# UNITED STATES PATENT AND TRADEMARK OFFICE

| APPLICATION NO. | FILING DATE | FIRST NAMED INVENTOR | ATTORNEY DOCKET NO. | CONFIRMATION NO. |
|-----------------|-------------|----------------------|---------------------|------------------|
| 10/583,628      | 06/20/2006  | Uwe Ackermann        | 2003P01978WOUS      | 4881             |

| <b>Office Action Summary</b> | <b>Application No.</b><br>10/583,628 | <b>Applicant(s)</b><br>ACKERMANN ET AL. |  |

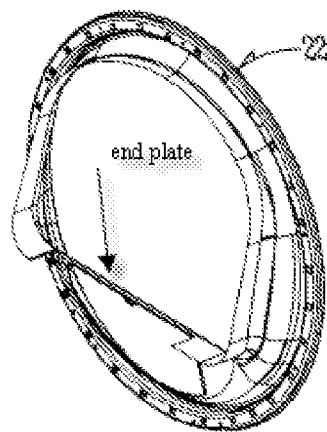
8. Regarding claim 10, Herr discloses a drier (abstract, line 2) comprising a rotary drum 20 (figure 4) that can be fed through a feed opening 22 (figure 4), through which drum process air is able to flow from a rear wall 24 (figure 4) into an end plate (figure 4 and figure A below) adjacent to the feed opening 22 (figure 4), and also comprising a drying basket 16 (figure 4) with a lattice type basket 18 (figure 4) projecting into the drum, which basket is supported demountably in at least one opening on the end plate (column 2, lines 54-56), wherein the drying basket 16 (figure 4) has a longitudinal support (figure 3 and figure B below) projecting into the drum, on which support an integral connecting device (figure 3 and figure B below) is formed, which device engages with the opening (column 2, lines 54-56) and a supporting section 28 (figure 3) which is supported against the end plate (column 2, lines 55-56), except for the integral connecting device being formed with a supporting section. However, Kretchman et al. teaches an integral connecting device 58 (figure 2) being formed with a supporting section 60 (figure 2)

9. Figure A.

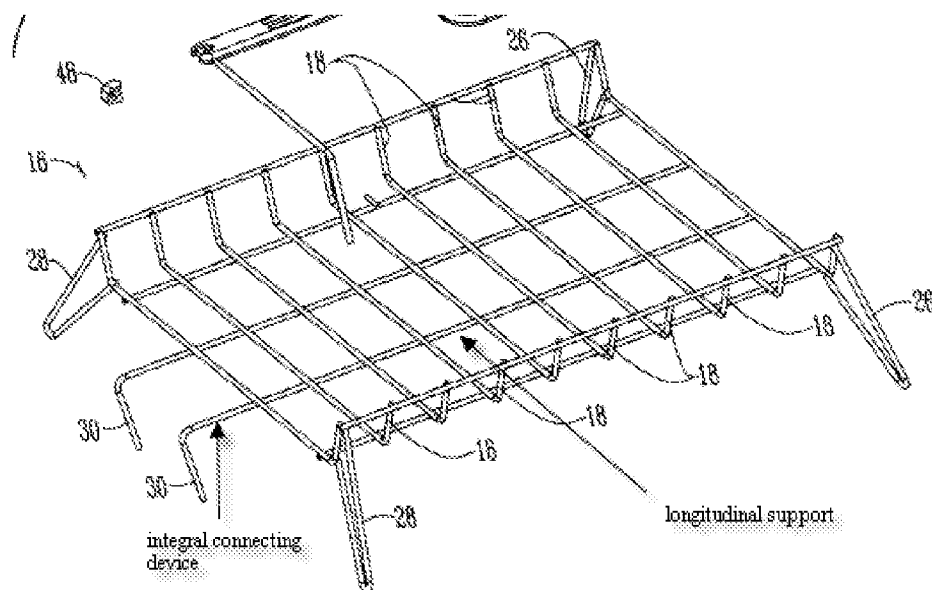
(figure 4) and each of the supporting sections 28 (figure 3) engaging a surface of the end plate (figure 4 and figure A above) to support the drying basket within the rotary drum, except for two basket openings disposed near opposing ends of the end plate, with each of the basket openings receiving one hooks and each longitudinal support including a supporting section. However, Vande Haar teaches two basket openings (“slots” column 3, lines 57) disposed near opposing ends of the end plate and with each of the basket openings receiving one hooks (figure 3, column 3, lines 56-58) in order to more securely mount the apparatus to the cover piece of the lint filter. Therefore, it would have been obvious to one of ordinary skill in the art at the time of invention was made to modify the Herr reference, to include two basket openings disposed near opposing ends of the end plate and with each of the basket openings receiving one hooks, as suggested and taught by Vande Haar, for the purpose of more securely mounting the apparatus to the cover piece of the lint filter. Kretchman et al. further teaches each longitudinal support 70 (figure 4) including a supporting section 60 (figure 2) in order to better direct airflow (column 3, lines 41-43). Therefore, it would have been obvious to one of ordinary skill in the art at the time of invention was made to modify the Herr and Vande Haar references, to include each longitudinal support including a supporting section, as suggested and taught by Kretchman et al., for the purpose of better directing airflow.

10. Figure B.

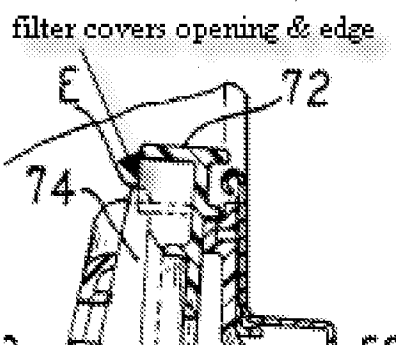
11. In regards to claim 11, Herr and Kretchman et al. disclose the claimed invention including the longitudinal support (figure 3 and figure B above) being designed as wire and the connecting device being a hook 30 (figure 3) formed on one end section of the wire, except for the hook and the support section being formed by a bending process. However, at the time the invention was made, it would have been an obvious matter of design choice to a person of ordinary skill in the art to form the wire hook and the wire support section by a bending process for the purpose of saving material when forming the hooks 30 (figure 3) and the front legs 28 (figure 3, column 2, lines 54-56), since applicant has not disclosed that having the hook and the support section being formed by a bending process provides an advantage, solves any stated problem, or is used for any particular purpose and it appears that the device would perform equally well with either designs.

13. In regards to claims 12 and 13, Herr and Kretchman et al. disclose the claimed invention including a longitudinal support on both longitudinal sides (figure 3 and figure B above), except for the end plate having two openings, wherein each longitudinal support engages with one of

21. Figure D.

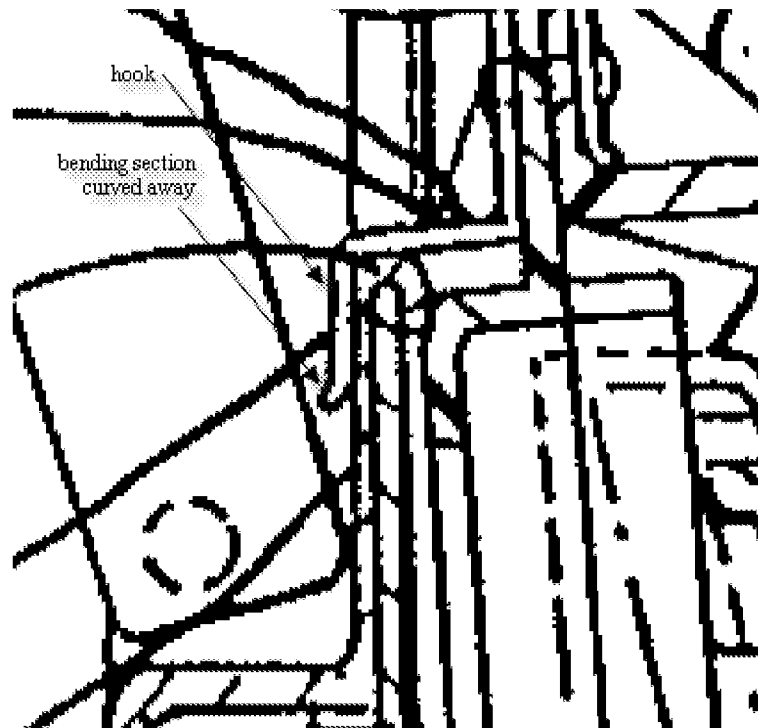
20. In regards to claim 18, Herr, Vande Haar, and Kretchman et al. disclose the claimed invention, except for each hook including a bending section curving away from the drying basket. However, Kretchman et al. teaches each hook including a bending section (figure 5 and figure D below) curving away from the drying basket in order to make it easier to attach the hook. Therefore, it would have been obvious to one of ordinary skill in the art at the time of invention was made to modify the Herr, Vande Haar and Kretchman et al. references, to include each hook including a bending section curving away from the drying basket, as suggested and taught by Kretchman et al., for the purpose of making it easier to attach the hook.
